# UNITED STATES PATENT AND TRADEMARK OFFICE

<b>Office Action Summary</b>	Application No. 10/518,378	Applicant(s) JENSEN, GEIR	
	Examiner. Jessie Fonseca	Art Unit 3637

## **DETAILED ACTION**

REPLACEMENT SHEET

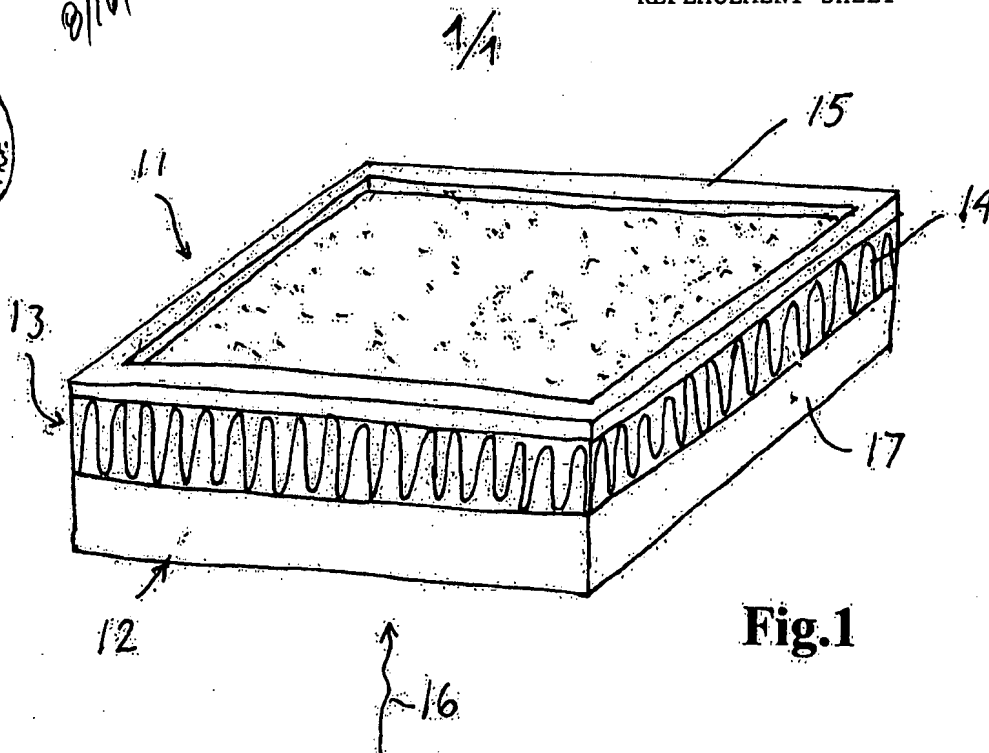
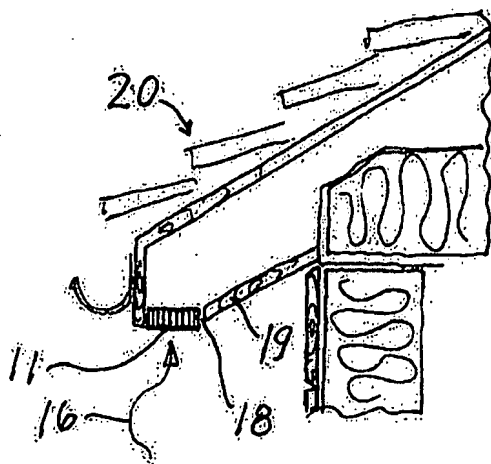
The drawings are objected to under 37 CFR 1.83(a). The drawings must show every feature of the invention specified in the claims. Therefore, the metal pipes filled with liquids, minerals or mixtures; and the grille body and the permeable element arranged in a frame must be shown or the feature(s) canceled from the claim(s). No new matter should be entered.

The drawing objection is withdrawn in view of the replacement drawings filed 5/29/07.
